Project	IEEE 802.16 Broadband Wireless Access Working Group < http://ieee802.org/16 >	
Title	In-band Transparent Relay Frame Structure	
Date Submitted	2006-03-14	
Source(s)	<p>Kanchei (Ken) Loa, Yi-Hsueh Tsai, Yung-Ting Lee, Heng-Iang Hsu Shiann-Tsong Sheu, Frank C.D. Tsai, Youn-Tai Lee, Chih-Chiang Hsieh, Hua-Chiang Yin, Institute for Information Industry 8F., No. 218, Sec. 2, Dunhua S. Rd., Taipei City, Taiwan.</p> <p>Gang Shen, Kaibin Zhang Alcatel-Lucent, Research & Innovation 388#, Ningqiao Road, Shanghai, China.</p> <p>[add co-authors here]</p>	<p>Voice: +886-2-2739-9616 loa@iii.org.tw</p> <p>gang.a.shen@alcatel-sbell.com.cn</p>
Re:	IEEE 802.16j-07/007r2: "Call for Technical Comments and Contributions regarding IEEE Project 802.16j"	
Abstract	This contribution proposes in-band transparent relay frame structure	
Purpose	Text proposal for 802.16j Baseline Document	
Notice	This document has been prepared to assist IEEE 802.16. It is offered as a basis for discussion and is not binding on the contributing individual(s) or organization(s). The material in this document is subject to change in form and content after further study. The contributor(s) reserve(s) the right to add, ame

Figure yyy Example of configuration for an in-band transparent relay frame structure

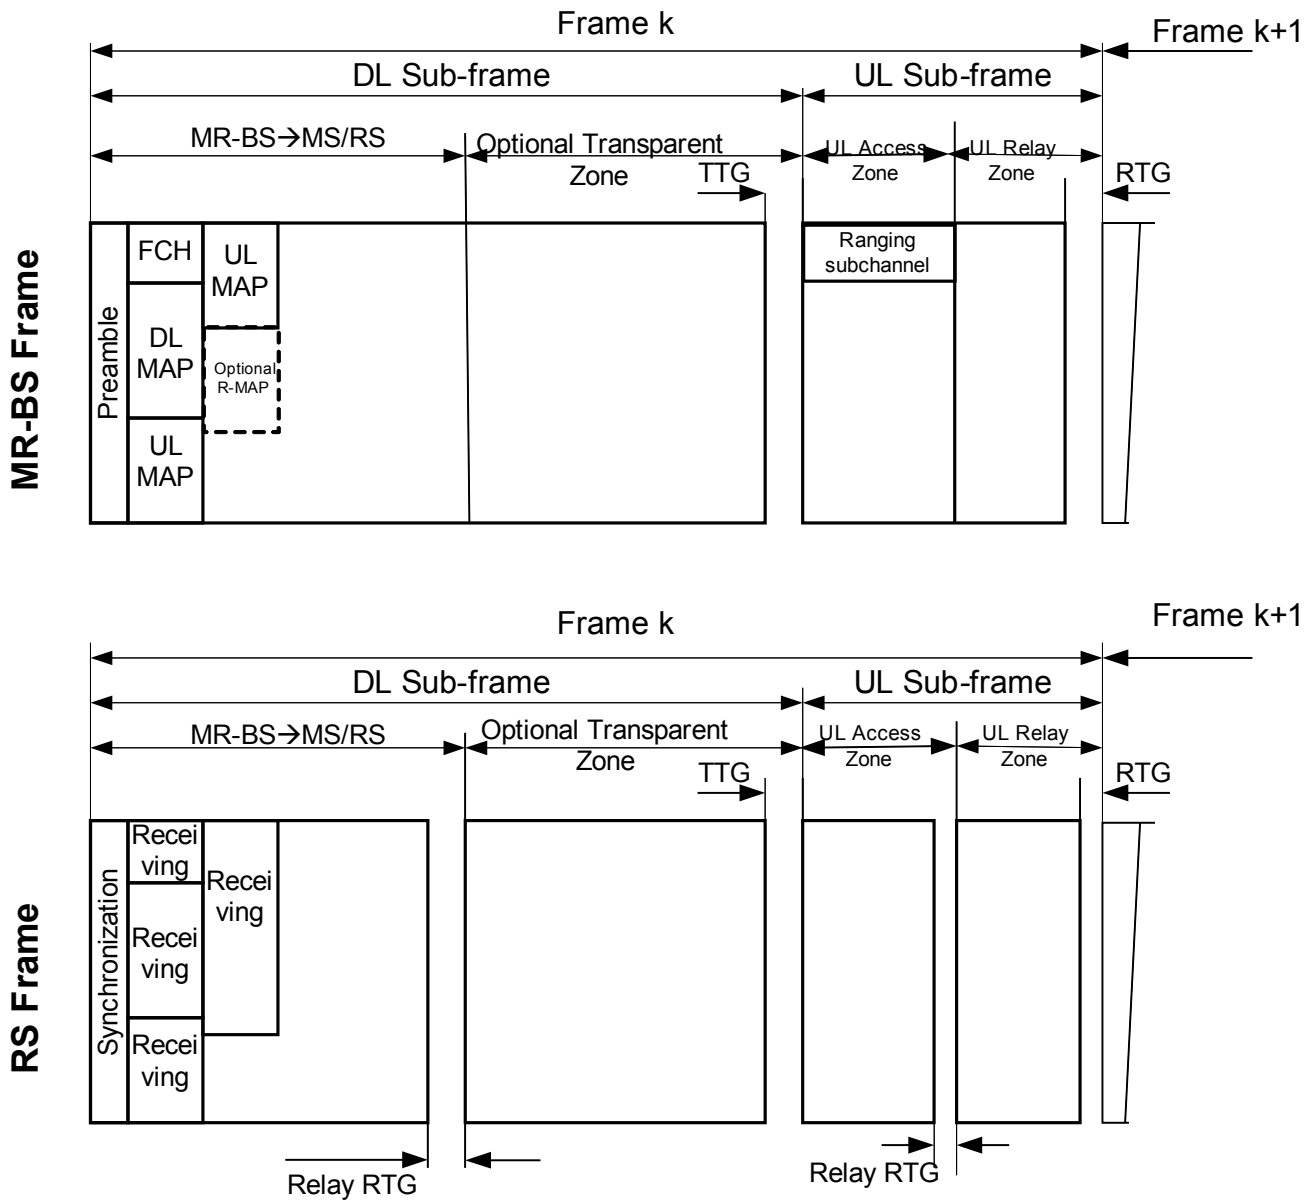
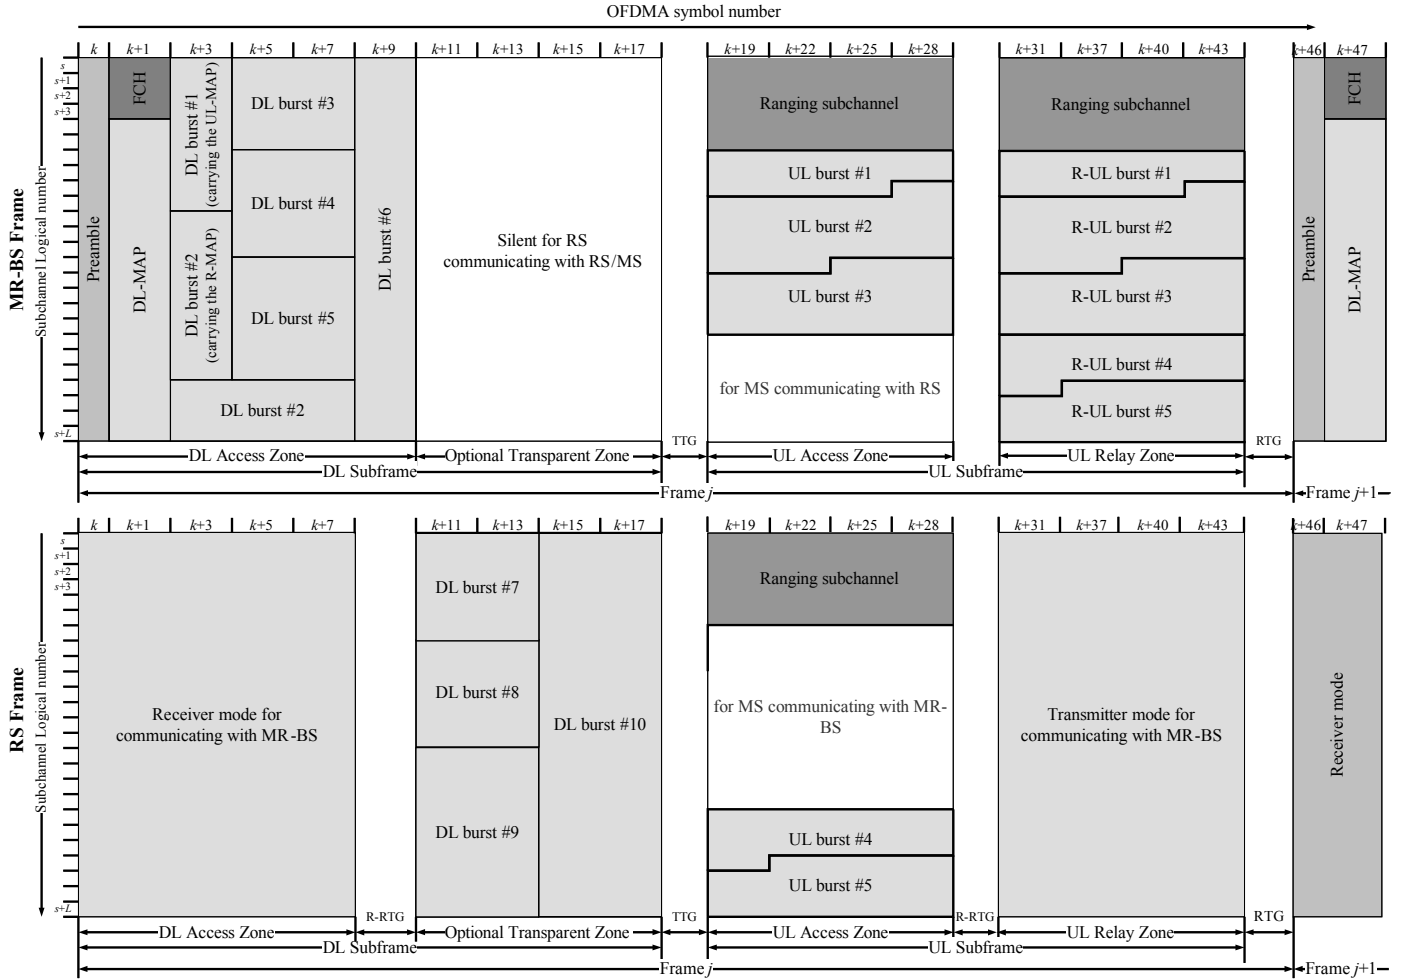
[Change the figure in section 8.4.4.7.1 “Frame structure for transparent mode” as indicated:]

[Replace Figure xxx with Figure yyy as follows:]
